Figure 2
Site Plan

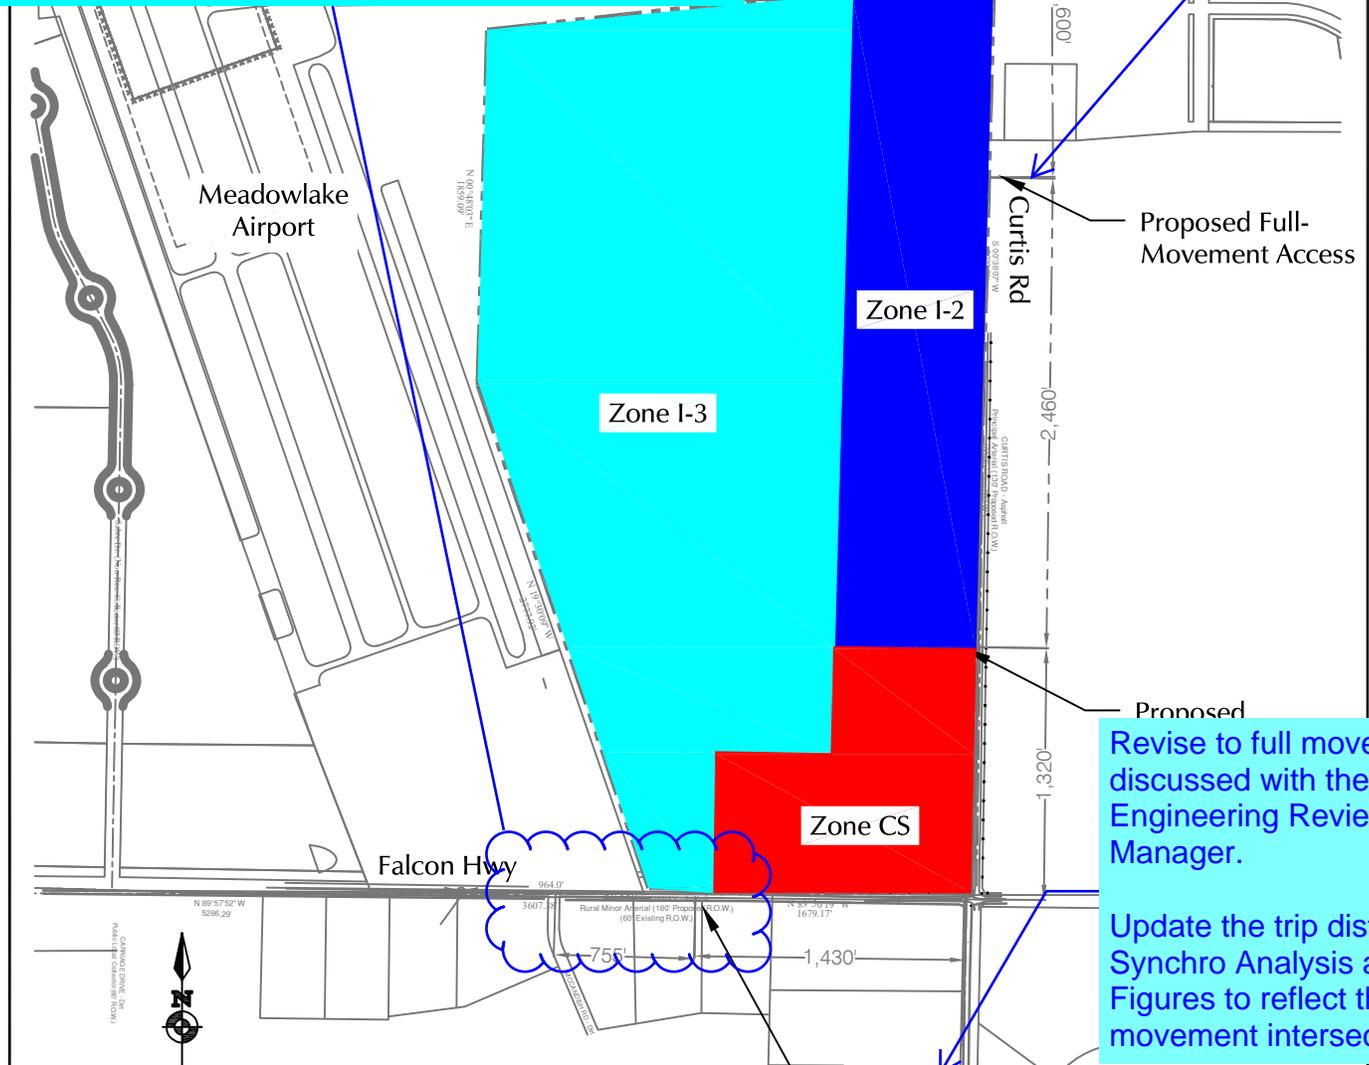
Update access location consistent with the directions provided by the Engineering Review Manager. (1/2 mile north of Curtis & Falcon intersection)

Revise to full movement as discussed with the Engineering Review Manager.

Update the trip distribution, Synchro Analysis and Figures to reflect the full movement intersection.
